ADDENDUM # 02

ISSUE DATE: May 24, 2007

PROJECT: KINGWOOD READINESS CENTER
Camp Dawson
Kingwood, West Virginia

**KINGWOOD READINESS CENTER
ADDENDUM #2 - CIVIL/SITE REVISIONS**

SHEET NUMBER:
SD-C-01

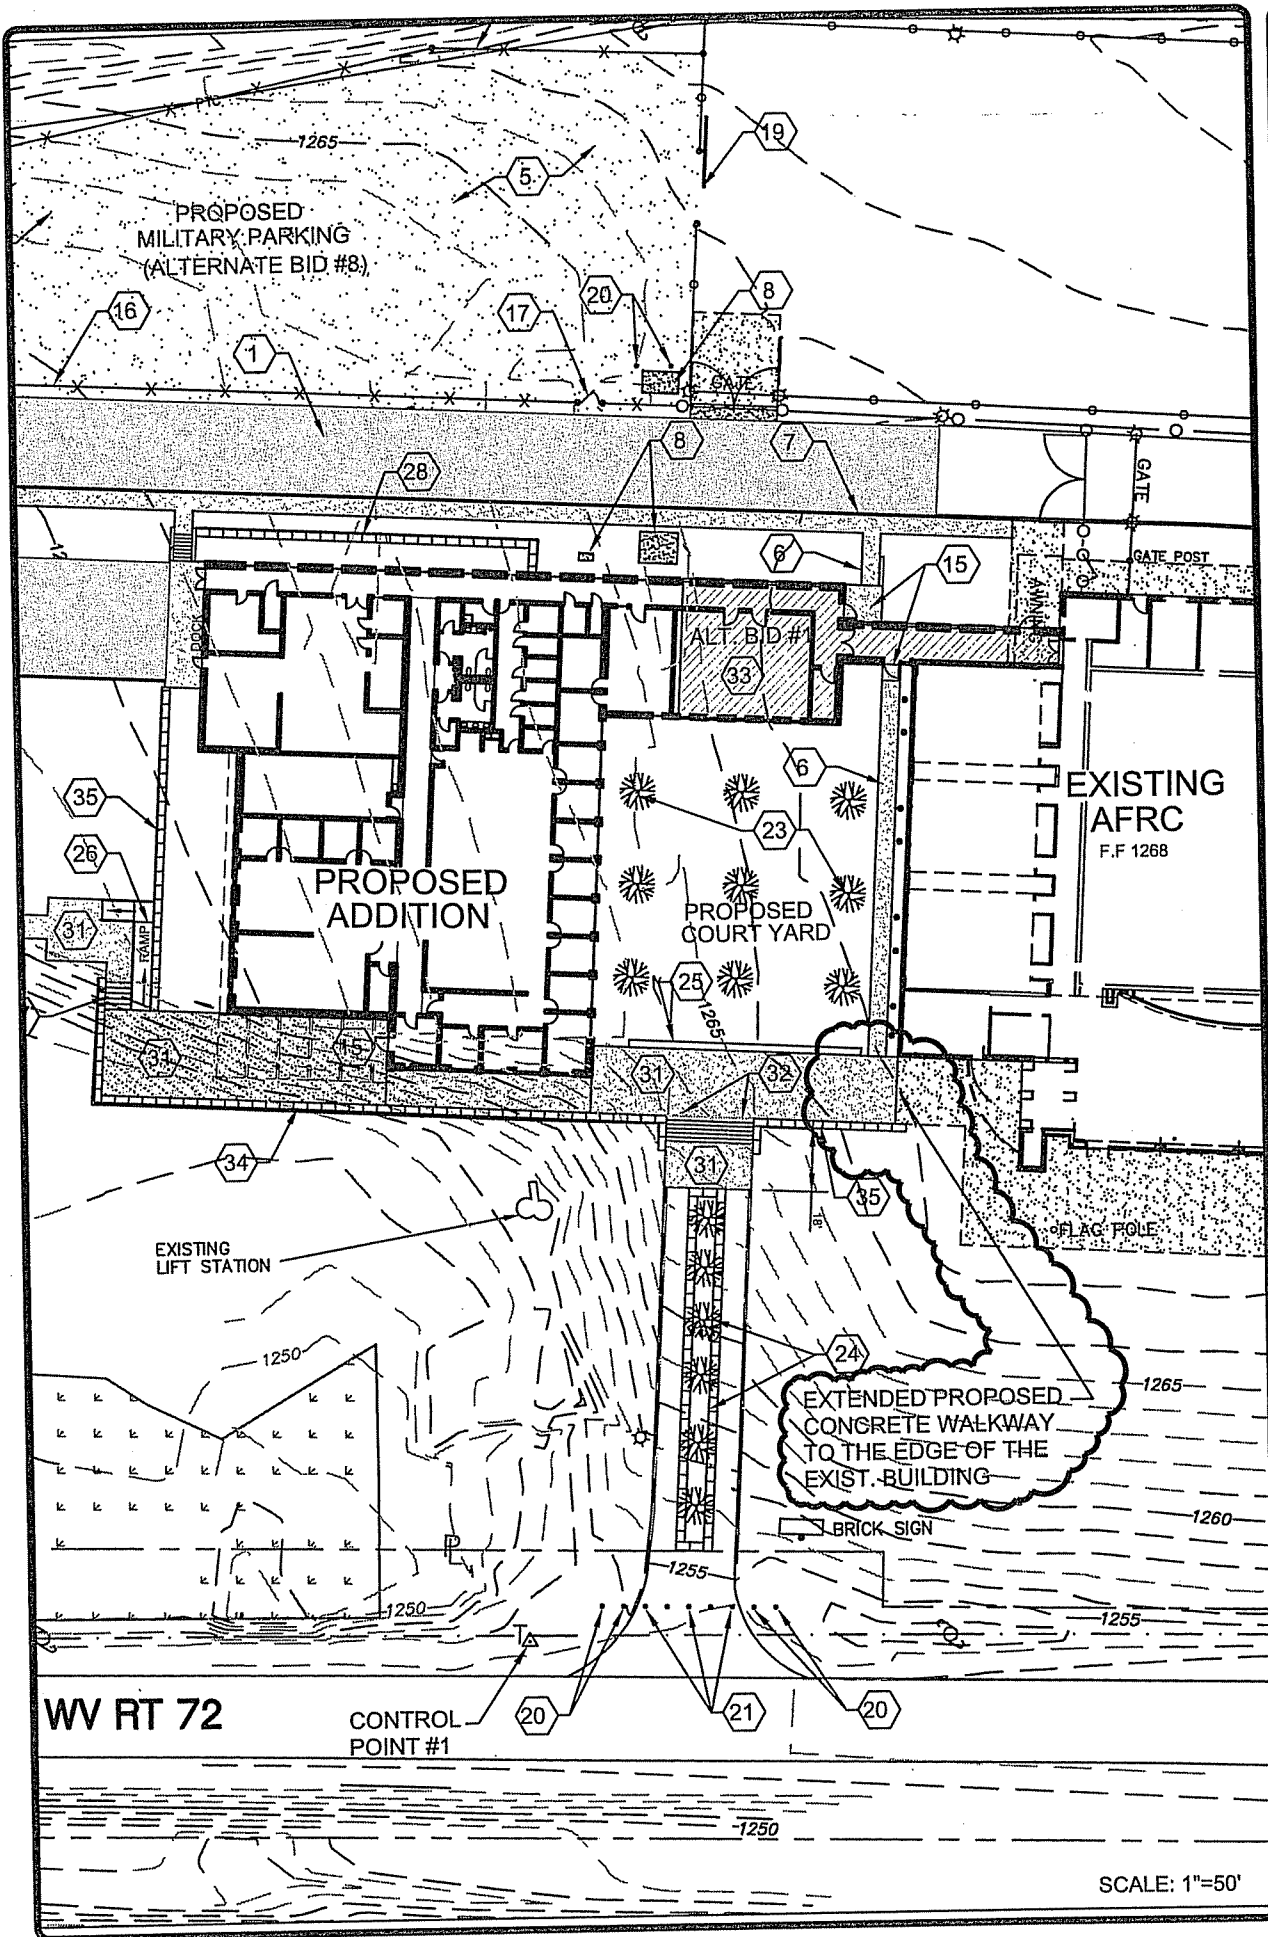
02-003: Refer to attachment titled, "Addendum #2 - Civil/Site Revisions".

Add the following 8 1/2" x 11" sheets: (Attached)	SD-C-01	Demolition Plan
	SD-C-02	Site Layout Plan
	SD-C-03	Grading and Drainage Plan
